DEVELOPMENT CONSENT MODIFICATION

Statement of Environmental Effects

AT 11 MOIRA PLACE – FRENCHS FOREST – NSW - 2086

DA2018/1799

Figure 2 – Proposed Updated Ground Floor Plan (Excerpt DA04 July 2019 - NTS)

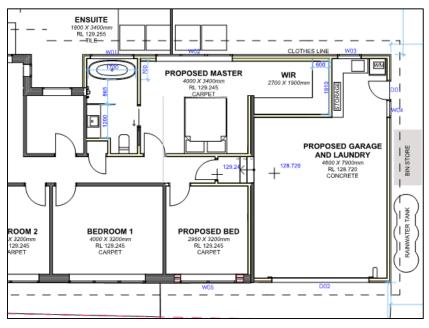
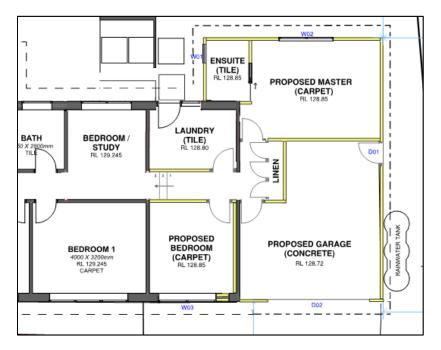
- 1. Existing laundry to be retained in situ.
- 2. New additions restricted to the east of the existing laundry window only, i.e. no modifications to the existing north wall (rear of the dwelling). Note overall area of new additions is approximately equivalent to the approved DA plans.
- 3. Revised location of Master Bedroom and Ensuite.

Figure 4 - Street Frontage - Proposed Modifications

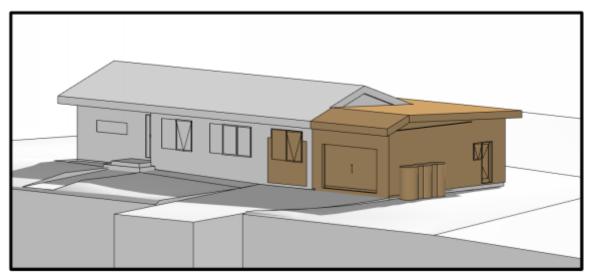
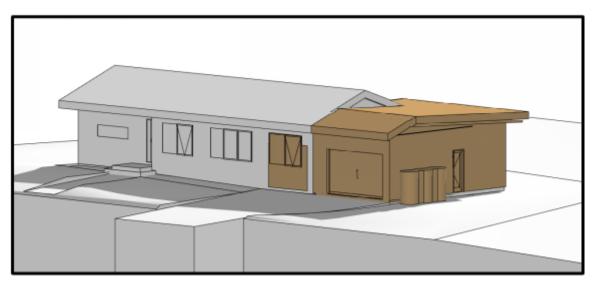
4. Minor changes to window and garage door position on street frontage.
